RE: National Desert Storm and Desert Shield Memorial Site Selection

National Desert Storm War Memorial - Tree Canopy Analysis

Figure 2. Site 2 has 48,809 square feet of tree canopy.

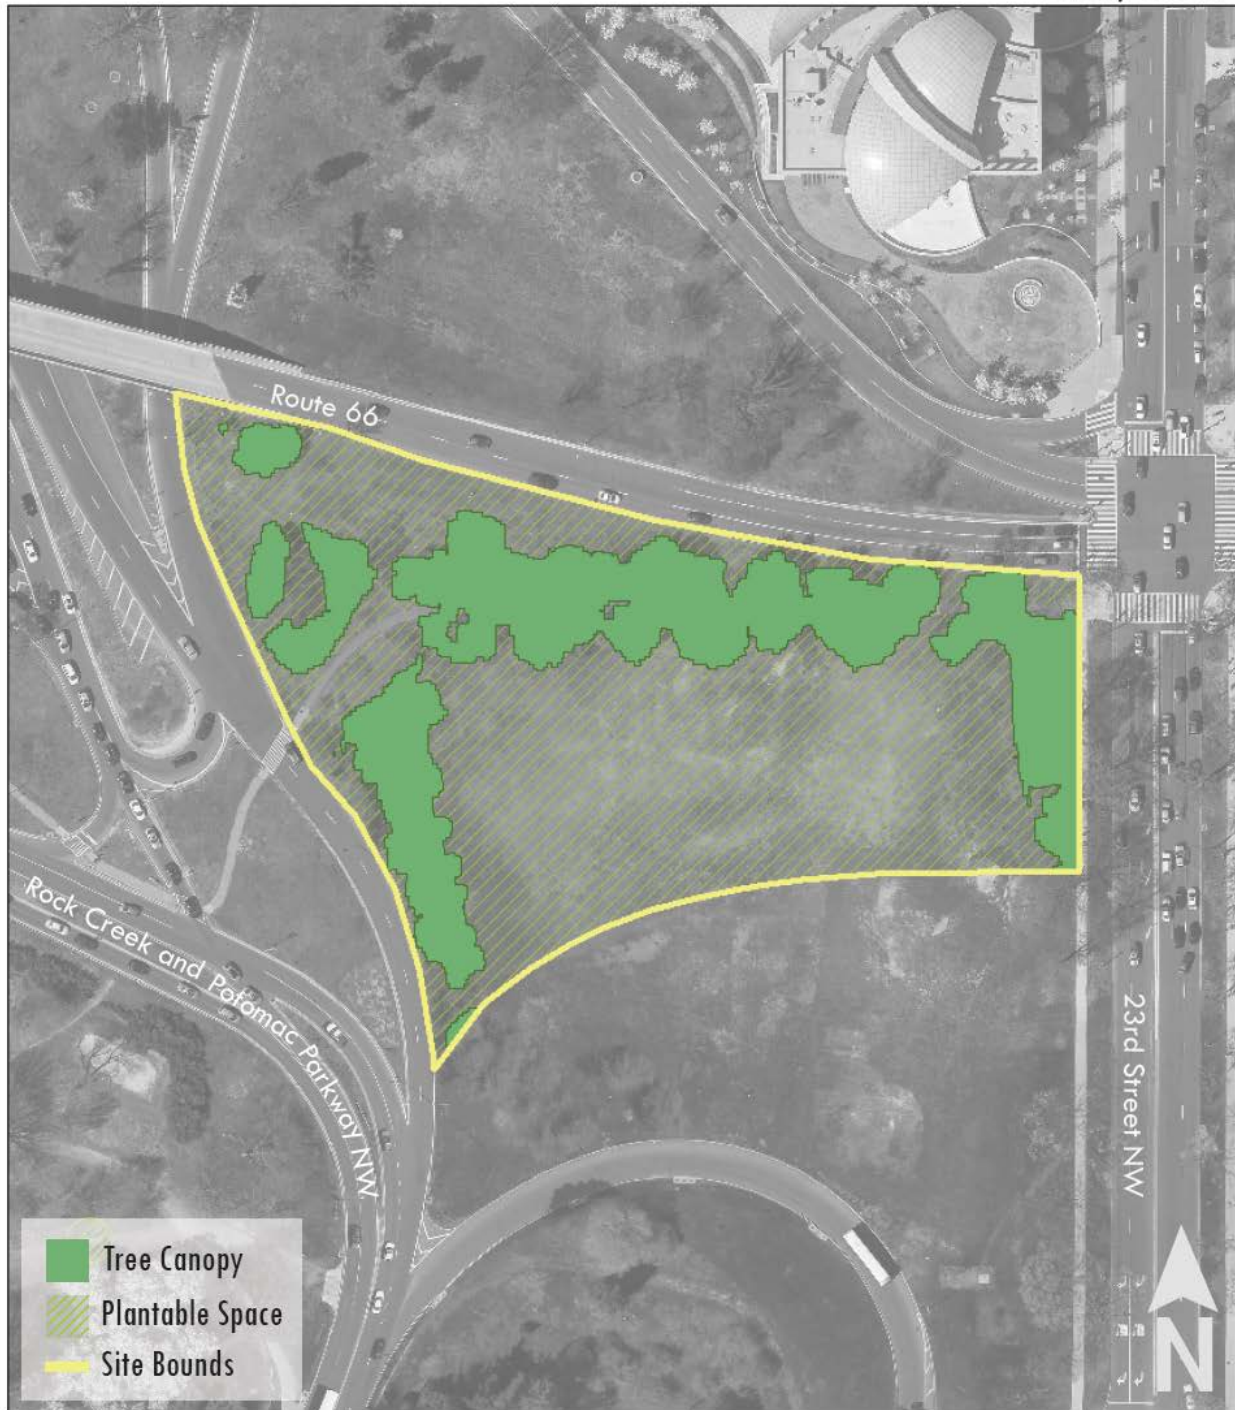
1. **Select the Constitution Avenue Terminus Area** as the home for the memorial. Site 2 has less tree canopy and more open space than Site 1, which will allow NPS and NCPC to preserve all trees around the future memorial (Figures 1 & 2).
2. **Adopt a 30% tree canopy goal:** Tree canopy currently shades approximately 30% of Site 2. We recommend protecting trees and/or planting new trees to maintain this 30% tree canopy.
3. **Build the memorial in open space:** To protect the existing trees at Site 2, build the memorial in the estimated 70,000 square feet of open space to the south, west, and east of existing trees (Figure 3).
